**Model** : GP605

**Ref. No.** : FF-T01-K1-000050-01

**Location** : CADF SEPARATION ASSEMBLY

**Subject** : PREVENTION OF 00EA JAMS CAUSED BY ADF DOUBLE FEEDING.

Fig. 1 Separation assembly (FG6-2746-050)

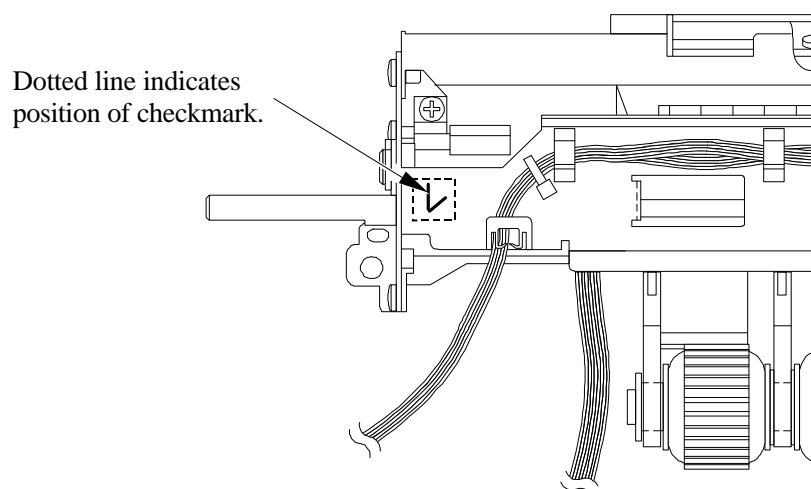
Deterioration of the feed performance has been prevented by modifying the distance between the separation assembly shafts. Note that a checkmark on the upper part of the assembly will be used to identify modified parts.

Fig. 2

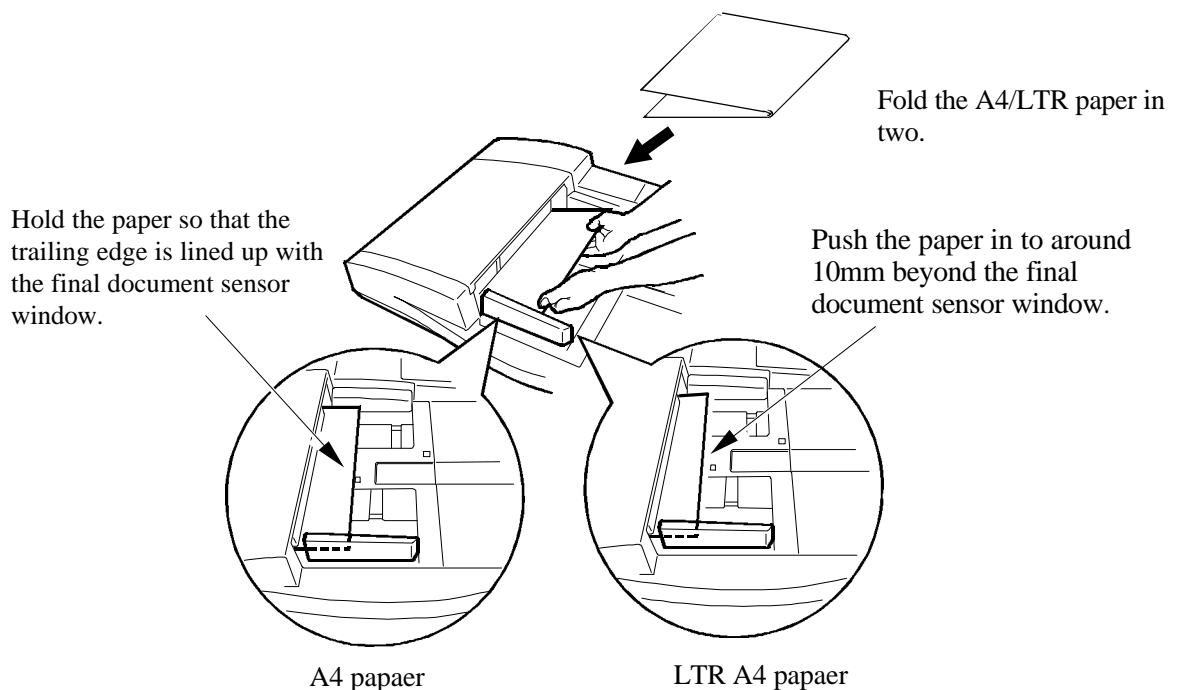
1. Perform cleaning by following the procedures described in the service manual (FY8-13FE-000); page 5-45, Chapter 5 - E - 1. Cleaning.
2. Fold a new sheet of A4/LTR copy paper in two and then insert it into the tray assembly. Holding the trailing end firmly, draw it out to the separation assembly and hold it there for about 3 to 5 seconds.

• The paper will be drawn through strongly, so be sure to hold onto the end firmly, as described in Fig. 2.
